RECALL BULLETIN 05V-262 (Rev. A)

DATE: OCTOBER 7, 2005
 MODEL YEAR: 1999 thru Early Production 2002
 CHASSIS MODEL: UD1200/UD1400
 BULLETIN NUMBER: SC-262
FILE IN THE ELECTRICAL SECTION OF THE TECHNICAL BULLETIN BINDER
 (Discard previous Recall Bulletin dated September 12, 2005)

**VOLUNTARY SAFETY RECALL CAMPAIGN NUMBER 05V-262:
 BATTERY CABLE INSPECTION AND/OR REPLACEMENT**

Figure A1 (1999 & 2000 MY)

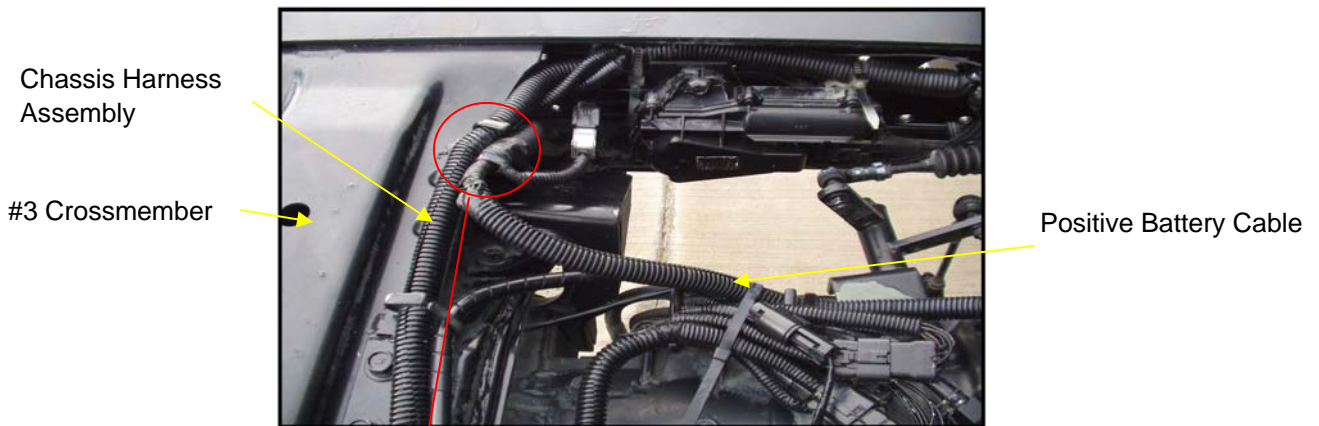
If the battery cable is not damaged inspect the Positive Battery Cable for proper routing as illustrated in Figure A1 and A2. Re-route the cable correctly as necessary. Proceed to Step 3.

Clamp the battery cable securely with the Chassis Harness to the cross member using the welded harness clip.

NOTE*: If the 3rd frame cross member is missing the welded retaining clip or is broken, use a Tie Strap PN 01552-00043 (from the Safety Recall Parts Kit) to secure the battery cable to the chassis harness as shown in Figure A2.

Figure B

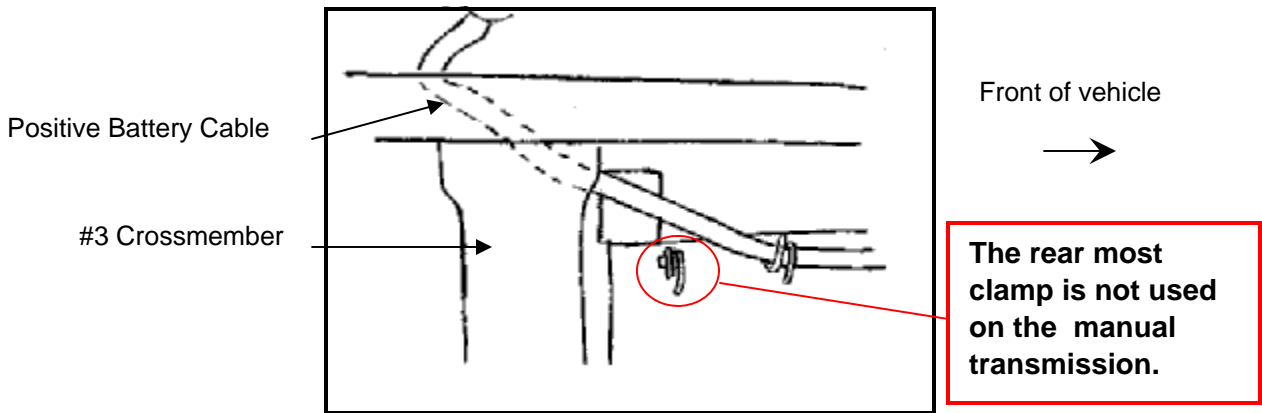
NOTE: Manual Transmission Models: Do not use the rear most retaining clip on the transmission shift cover to secure the battery cable, see Figure B.

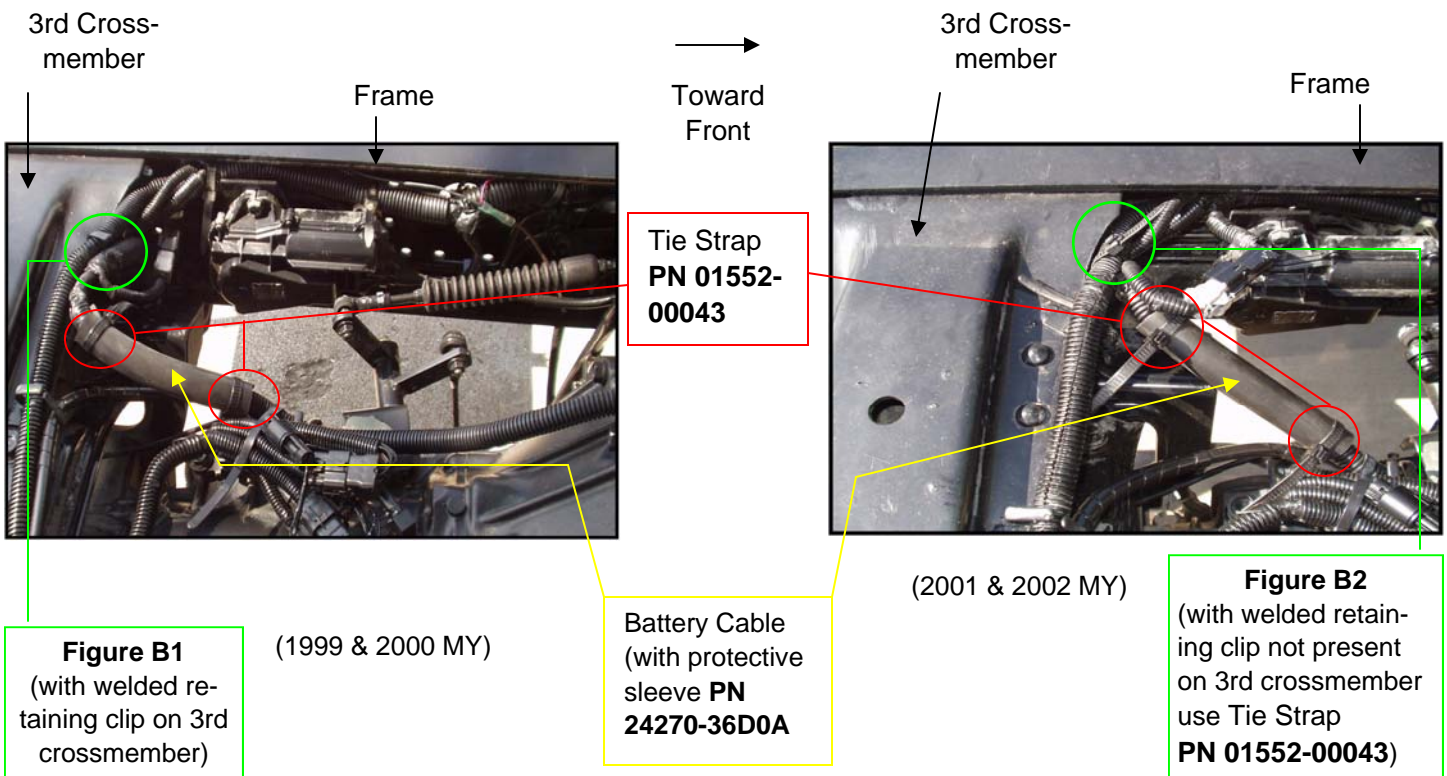
Install the battery cable Protective Sleeve **PN 24270-36D0A** from the Safety Recall **Parts Kit** around the battery cable.

Use 2 Tie Straps **PN 01552-00043** to secure the Protective Sleeve at each end as shown in Figure B1 if the welded retaining clip is present.

Use 2 Tie Straps **PN 01552-00043** to secure the Protective Sleeve at each end and a 3rd tie strap to secure the battery cable to the chassis harness at the crossmember as shown in Figure B2 if the welded retaining clip is not present.

Figure C

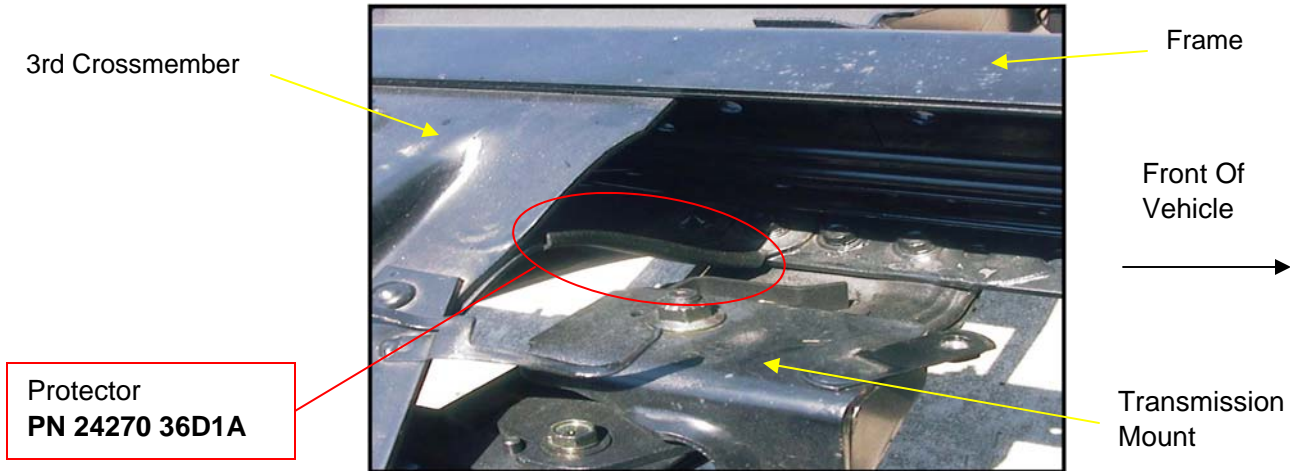
Install the 3rd Frame Cross Member Protector **PN 24270-36D1A** as shown in Figure C.
